**Seattle  
Design  
Commission**

**MINUTES OF THE MEETING**

**6 March 2003**

Projects Reviewed

Perspective of channel.

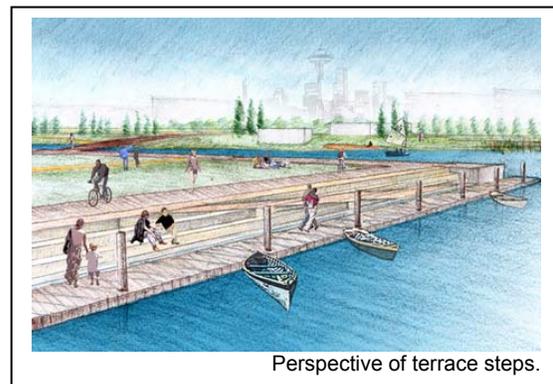
- Believes that there are really two proposals here rather than three. Feels that the team raised interesting questions about landscape interacting with land and water and manmade land interacting with water. Sees a conflict between the diagrammatic and phenomenological condition; the first diagram shows an extension of the city grid, but also an island. Feels that scheme three is about an extension of the city and does not believe that you really feel like you are on an island on this site. Suggests the notion of the canal and island is a red herring and prefers scheme 3.

- Supports the idea of a channel and feels that it is all about fun and body experience and there is nothing like that in Seattle now. Believes that a sense of history is lacking and there should be more of a visual connection to what used to be there to indicate how much has changed and how strange and toxic the site is.

- Proponents stated that the canal is real and shows what the site used to be—water. They are digging down and exposing what the site was.
- Feels that because the canal is straight it does not remind people of the shoreline, but it does say that everything around is manmade. Would like to see the sense of being on an island enhanced when you cross over.

- Supports big Mercer and little Valley and supports having a canal, but would like to know why the canal has to be straight.
  - Proponents stated that the water needs to be straight so as not to create any eddies that would allow create a spot for mosquitoes and garbage collection. In addition, kayaks and

canoes want to be able to go through and straight works better for that function.

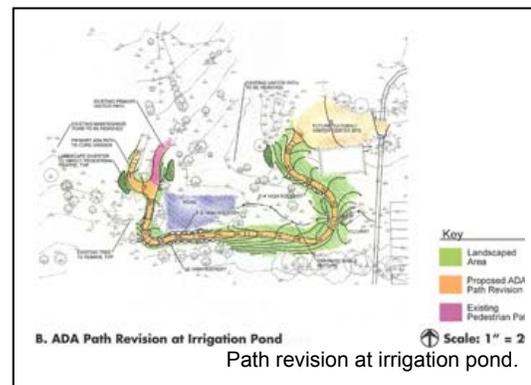
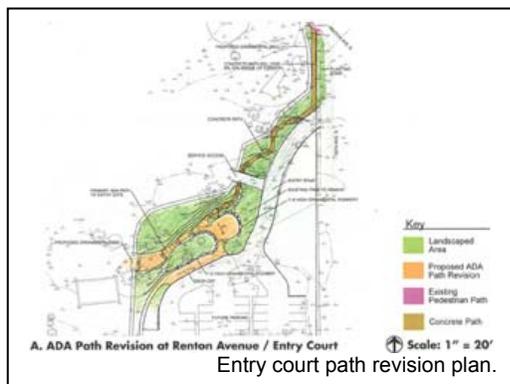
- In the distinction between the primary route and the ADA route, feels that the primary route should be the one that is accessible. Urges the team to put interpretive elements and amenities along the accessible route. Feels that it is clear how cars and buses get into the site, but is less clear where to go once you are out of a vehicle.

- Suggests that what proponents are calling ADA should be the primary route.
  - Proponents stated that it is an issue of wording and that they are looking at the primary route as the one that everyone can take through the site. They heard from the community that there is not one way or a preferred way to go through the site. People like to wander and get lost and take multiple routes.

- Urges the team, when they make the maps and signs, to map ADA as primary route.
- Appreciates the subtlety and care with which the design team has taken in the entry. Even when people drive in, they will experience the garden and with people walking through the parking area, cars will be encouraged to go more slowly. Feels that this is a successful design.

- Proponents stated that the circulation works from a drainage perspective and they are working with SPU who preferred this orientation. Proponents feel that they can work with this and they will have to deal with potential conflict of buses and cars only during peak use periods. People walk through the parking lot and drop-off zone.

- Would like to clarify whether the same kinds of amenities and interpretation would happen on all routes.
  - Proponents stated that just that one piece of path closest to Renton is not ADA accessible. They feel that it is not worth the expense to regrade it and is not historically appropriate. They are maintaining the original historic entrance to tie back historically.
